**Attachment 1 - PLN18/0183 - 19 Down Street Collingwood - Internal Urban Design comments  
(public realm only) (s57A plans)**

**TO:** Chris Stathis (Statutory Planning)  
**FROM:** Daniel Perrone (Urban Design)  
**DATE:** 06 Jan 2019  
**SUBJECT:** 19 Down Street, Collingwood  
**APPLICATION NO:** PLN18/0183

**DESCRIPTION:** Section 57a amendment to planning application pln18/0183. Key changes include a reduction in the scale of the proposed development from 14 to 8 storeys (plus basement levels), provision of upper level setbacks and changes to the materiality and massing of the development. The amendment results in a lesser car parking reduction being proposed. The amended proposal can be described as the construction of a building (8 storeys plus basement levels), including offices and ground floor food and drink (cafe) premises (permit not required for uses) and a reduction in the car parking requirements.

Ground Floor Plan  
Scale: 1:150 @ A3

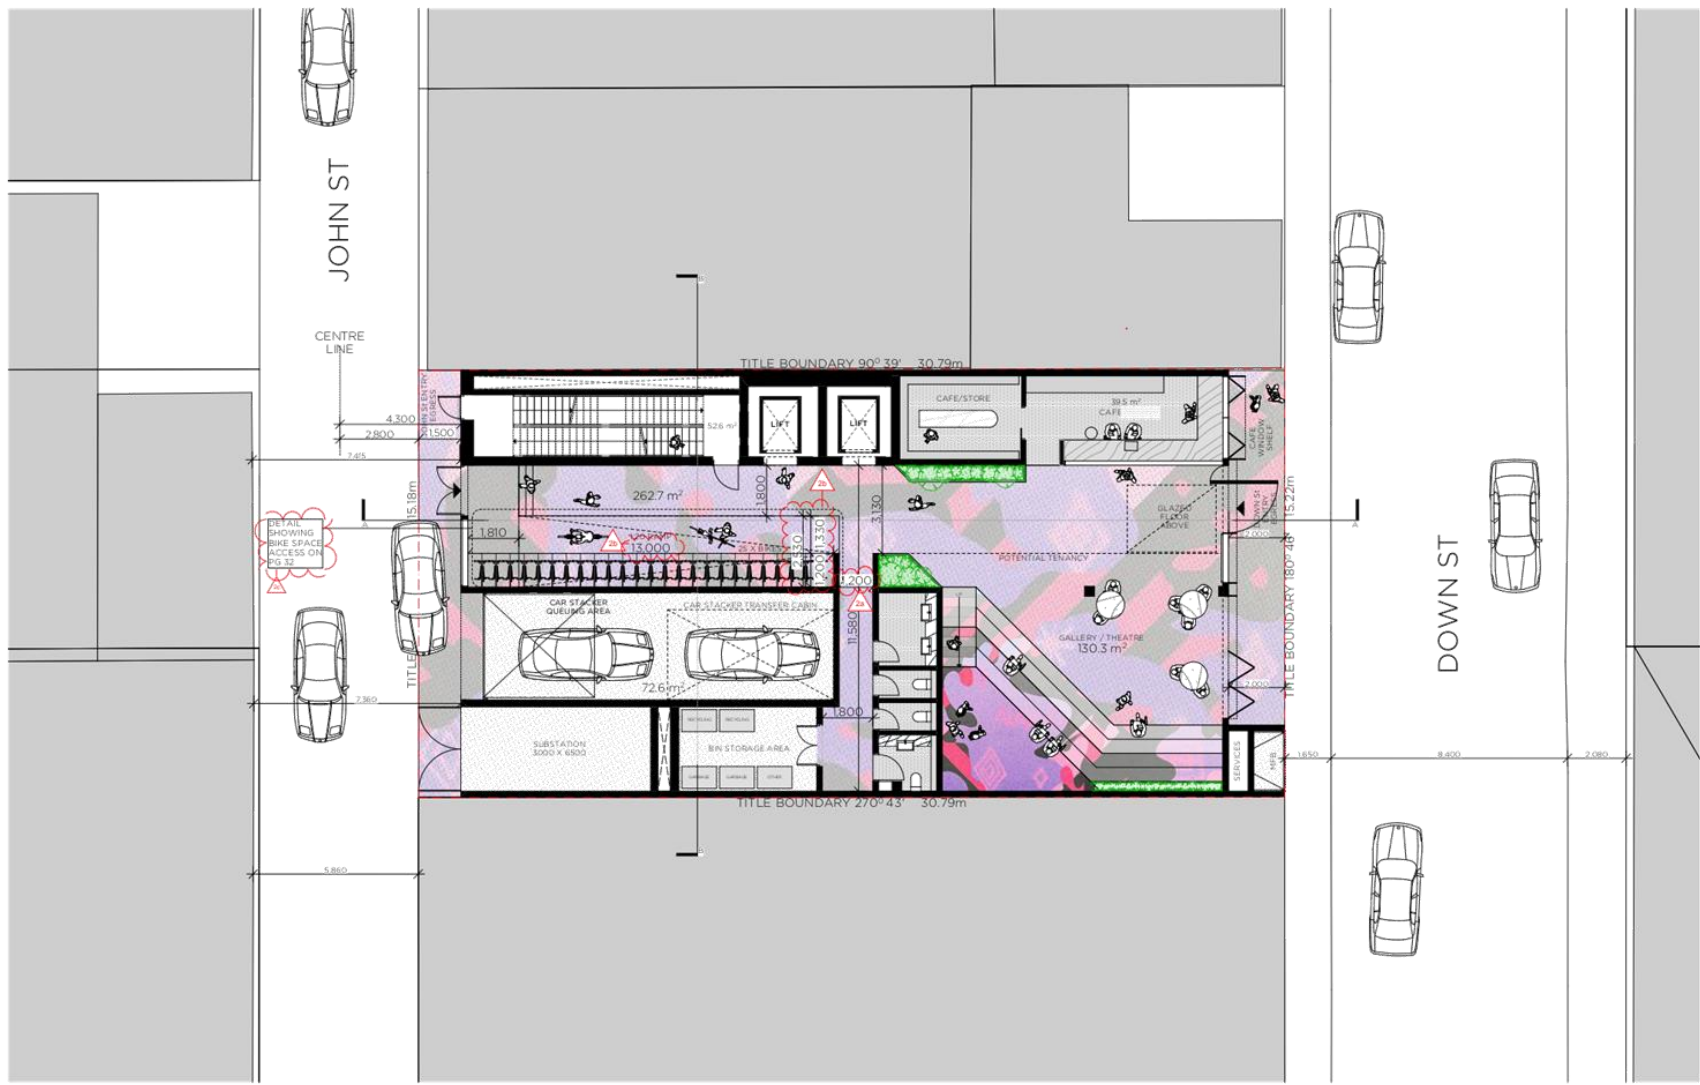
- The proposed ground floor setback is supported to create a pedestrian refuge around the building entrance, however, it is unclear whether the building and car-stacker entrances are intended to be flush with John St or whether a step and/or ramp is proposed. Currently, Section A (Page: 029) shows a 100mm level difference between the building and the roadway, however no details around the vehicle entry are provided.

- Provide details showing how the proposed building will tie-in to existing levels at John St, including any proposed step or ramp to pedestrian entrance, and any proposed ramp / change in grade between vehicle entrance and John St.

- Some form of pedestrian protection needs to be provided around the building entrance. This could be through the installation of a step, or if a flush threshold is preferred, bollards should be installed along the site boundary.

- **NOTE: If a ramped / flush threshold solution is proposed, the applicant must provide civil engineering details demonstrating how water ingress into the proposed building will be prevented.**

Item	Assessment
<b>Access Arrangements</b>	
Development Entrance – John Street Frontage	The width of the development's car park entrance is not dimensioned on the drawings.
Visibility	Convex mirrors are to be installed on either side of the car park entrance and are to be depicted on the drawings.
<b>Car Parking Stacker System</b>	
Car Stacker Device	All on-site parking would be contained within a fully automated car parking system, the Wöhr Multiparker 740. This model has a platform width of 2.2 metres and length of 5.25 metres to accommodate a B85 design vehicle.
Floor to Ceiling Height	The floor to ceiling height on the Ground Floor level has not been dimensioned on the drawings.
Vehicle Clearance Heights	The mechanical stacker device for this development provides a minimum height of 1.8 metres for at least 25 per cent of the total number of spaces to satisfy <i>Design standard 4 – Mechanical parking</i> .

Item	Details
Development Entrance – John Street Frontage	The width of the car park entrance is to be dimensioned on the drawings.
Visibility	The positions of the convex mirrors are to be shown on the drawings.
Floor to Ceiling Height	The floor to ceiling height clearance on the Ground Floor level is to be shown on the drawings.
Internal Concrete Slab	For any new internal concrete works, the finished floor levels along the edge of the slab must be set 40 mm above the edge of John Street – Council Infrastructure requirement.
Bicycle Considerations	The bicycle requirements for this development are to be referred to Council's Strategic Transport unit for comments.
